## ANN ARBOR HISTORIC DISTRICT COMMISSION

### Staff Report

**ADDRESS:** 1540 Cedar Bend Drive, Application Number HDC16-164

**APPLICATION:** The applicant seeks HDC approval to repave the front walkway with pavers, and install a paver driveway on a drive that is currently gravel.

PRIMA  
LANDSCAPE & IRRIGATION

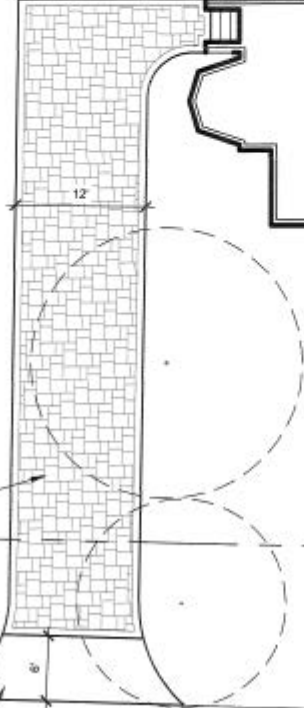
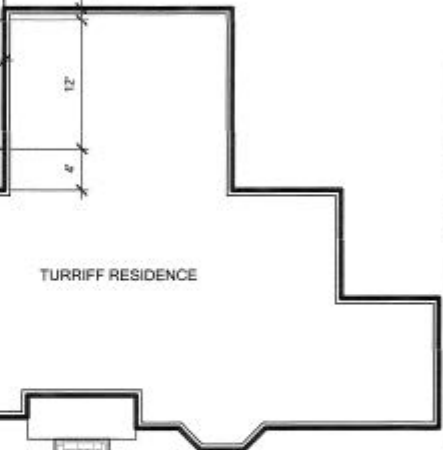
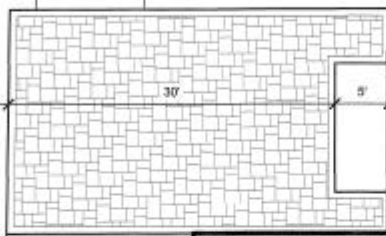
1. The driveway is gravel, and the applicant states that shifting gravel and drainage/runoff issues would be resolved by paving. Snow removal is a problem in the winter because of the large size of the gravel on the driveway and the slope of the site is not graded for proper drainage, and the sloped part becomes slippery and difficult to navigate. Unilock pavers are an appropriate surface that won't be mistaken for a historic material. The extent of the pavers matches the current extent of the gravel.

2. The applicant states that the stone paver walkway is falling apart and in need of repair. The walkway was not paved in the 1947 aerial photo (see end of staff report), though a path is shown in nearly the same location. Later aerials distinctly show a paved walkway. Since the pavers were installed after 1947, staff is not concerned about retaining the current stone material. Replacing it with Unilock pavers to match the driveway is an

3. The landscaping shown on the supplied drawing does not have any hardscape features that would trigger the need for HDC review.
4. Staff recommends approval of the application. The proposed work is generally compatible in exterior design, arrangement, texture, material and relationship to the rest of the building and the surrounding neighborhood and meets the *Ann Arbor Historic District Guidelines* for driveways and paved areas and landscape features, and *The Secretary of the Interior's Standards for Rehabilitation*, in particular standards 1, 2 and 10, and the guidelines for building site.
